Project	IEEE 802.16 Broadband Wireless Access Working Group < http://ieee802.org/16 >	
Title	Comments on the 16m protocol structure of SDD	
Date Submitted	2008-03-10	
Source(s)	Kanchei (Ken) Loa, Yung-Ting Lee, Youn-Tai Lee, Hua-Chiang Yin, Yi-Hsueh Tsai, Chun-Yen Hsu, Tsung-Yu Tsai, Yi-Ting Lin, Chih-Wei Su, Shiann-Tsong Sheu, Yih Guang Jan, Yang-Han Lee, Ming-Hsueh Chuang, Hsien-Wei Tseng Institute for Information Industry 7F, No. 133, Sec. 4, Minsheng E. Rd., Taipei City 105, Taiwan	Voice: +886-2-66000100 E-mail: loa@iii.org.tw * < http://standards.ieee.org/faqs/affiliationFAQ.html >
Re:	IEEE 802.16m-08/005- Call for Contributions on Project 802.16m System Description Document (SDD) Topic: Comments on IEEE 802.16m-08/003	
Abstract	This contribution proposes modifications to 16m protocol stack and associated Data Plane and Control Plane Processing Flows to enable the multihop relay.	
Purpose	For discussion and approval by IEEE 802.16 Working Group

Comments on the 16m protocol structure of SDD

Figure 7 The IEEE 802.16m Protocol Structure

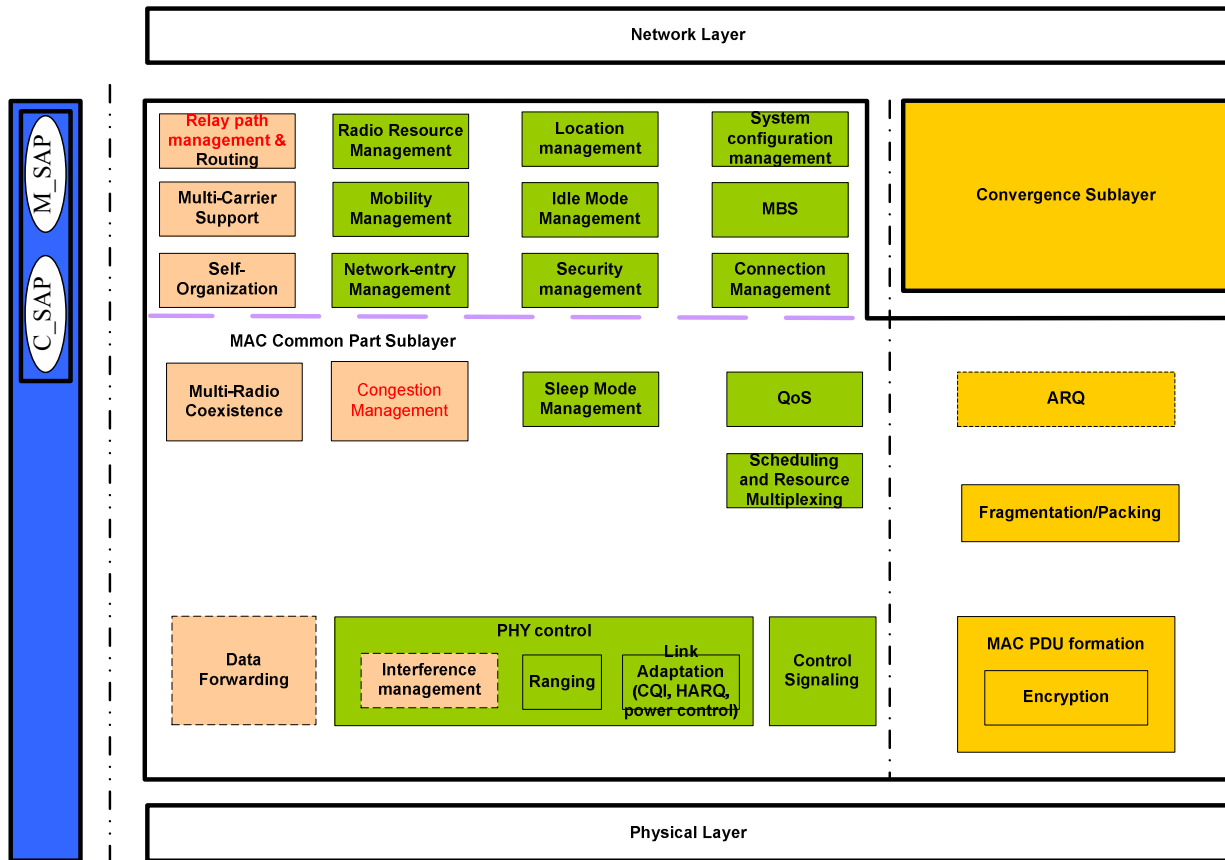
[Modify the following text and Figure 7 in Line 7, Page 15? as indicated:]

The IEEE 802.16m follows the MAC architecture of current IEEE 802.16e and includes additional functional blocks for 802.16m specific features (see Figure 7). The following additional functional blocks are included:

- Routing Relay Path Management & Routing
- Self Organization
- Multi-Carrier
- Multi-Radio Coexistence

Self Organization block performs functions to support self configuration and self optimization mechanisms. The functions include procedures to request RSs/MSs to report measurements for self configuration and self optimization and receive the measurements from the RSs/MSs.

Relay path management and routing block performs functions to support multihop relay mechanisms. The functions include procedures to establish/change/remove DL and UL relay paths between the 16m BS and 16m MS with relay stations.

Congestion management block performs functions to support congestion control and flow control. The functions include procedures to perform congestion signaling and flow control between the 16m BS and 16m MS with relay stations.

Figure 10 The IEEE 802.16m RS Data Plane Processing Flow

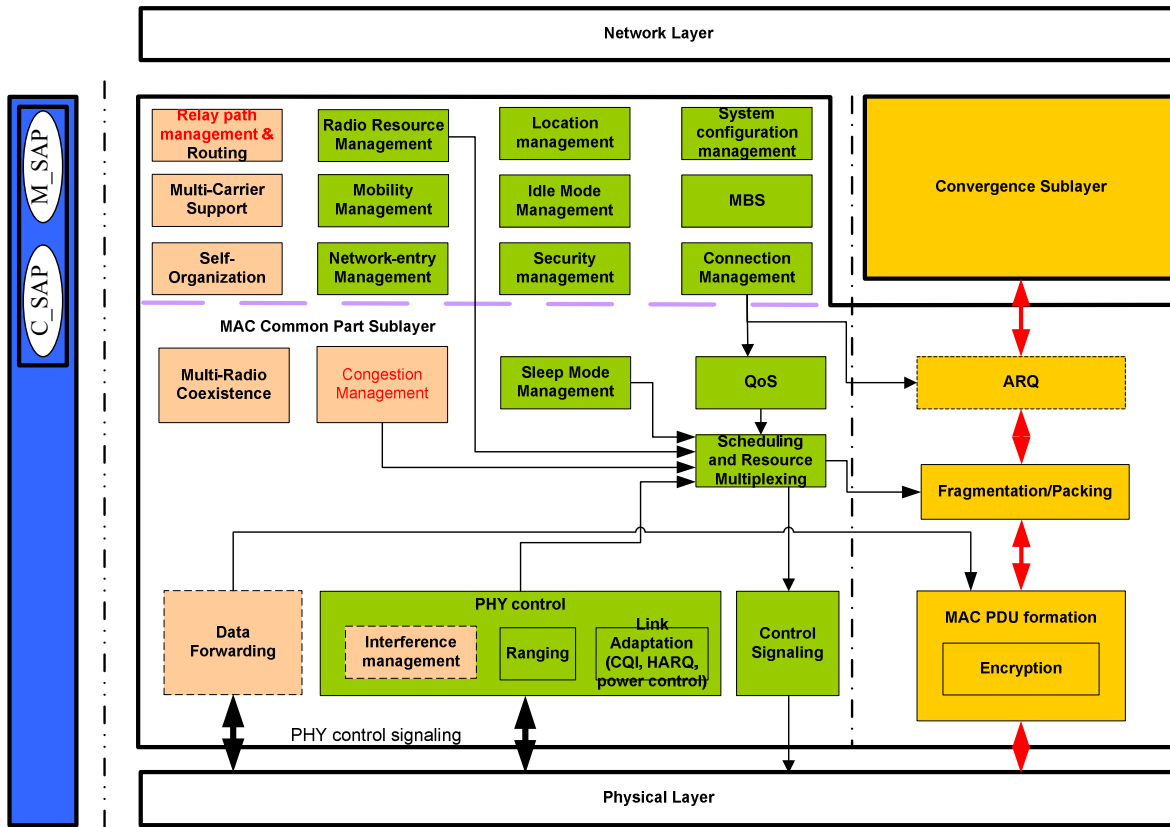
[Insert subclause 8.2.3 in Line 3, Page 18? as indicated:]

8.2.3 The IEEE 802.16m RS Data Plane Processing Flow

The following Figure 10 shows the user traffic data flow and processing at the RS. The red arrows show the user traffic data flow from the physical layer to the physical layer. A physical layer SDU is processed by MAC PDU formation function (if present), the fragmentation/packet function (if present), the ARQ function (if present) and the convergence sublayer function (if present). Afterwards, the receiving packet is sent to the physical layer. The black arrows show the control primitives among the MAC CPS functions and between the MAC CPS and PHY that are related to the processing of user traffic data.

Figure 11 The IEEE 802.16m RS Control Plane Processing Flow

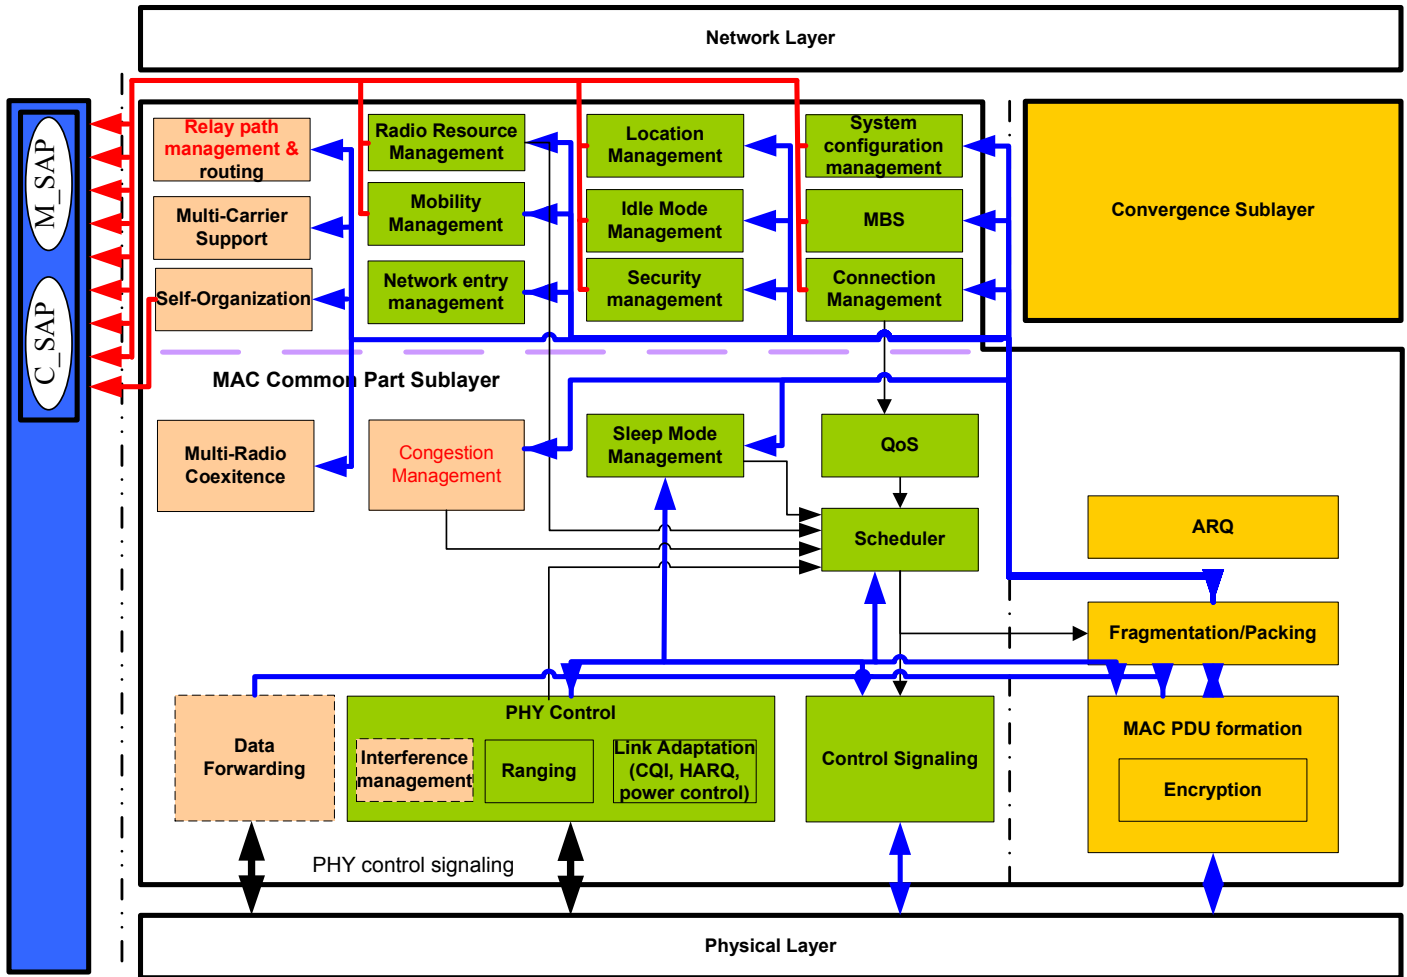
[Insert subclause 8.2.3 in Line 3, Page 18? as indicated:]

8.2.4 The IEEE 802.16m RS Control Plane Processing Flow

The following figure 11 shows the MAC CPS control plane signaling flow and processing at the RS. On the transmit side, the blue arrows show the flow of control plane signaling from the control plane functions to the data plane functions and the processing of the control plane signaling by the data plane functions to form the corresponding MAC signaling (e.g. MAC management messages, MAC header/sub-header) to be transmitted over the air. On the receive side, the blue arrows show the processing of the received over-the-air MAC signaling by the data plane functions and the reception of the corresponding control plane signaling by the control plane functions. The black arrows show the control primitives among the MAC CPS functions and between the MAC CPS and PHY that are related to the processing of control plane signaling.
